# ADDENDUM A – RNL SATELLITE KIT UPGRADE

## FIELD WIRING INSTRUCTIONS

This addendum is for Master to Satellite Configurations for dispenser’s using Pre-Released Boards or Released Boards.

For Satellite Control Board (135146 Rev A1) and Pulse Output Board (131480 Rev F1) The field wiring shown below is done in the Master dispenser. **Note:** The satellite wiring is described in the standard satellite kit instructions.

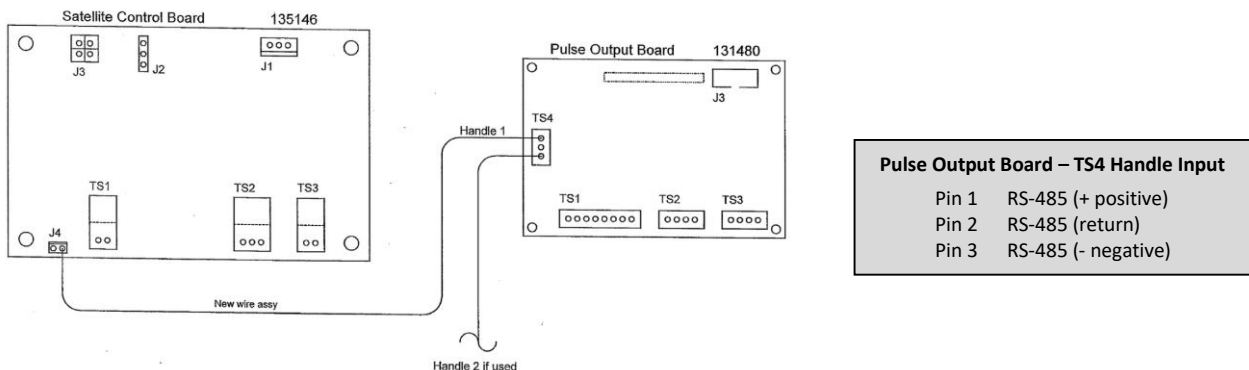
1. Connect the wire harness (142708) to the Satellite Control Board (135146 Rev A1) and to the Pulse Output Board (131480 Rev F1).
  - a. Plug the 2-position connector into the **[J4]** connector on the Satellite Control Board.
  - b. Plug the stripped wire into **[TS4]** on the Pulse Output Board. **Note the location of the Handle Inputs.**
    - Handle One - Plug the stripped end of the wire into Pin 1 of **[TS4]**
    - Handle Two – Plug the stripped end of the wire into Pin 3 of **[TS4]**
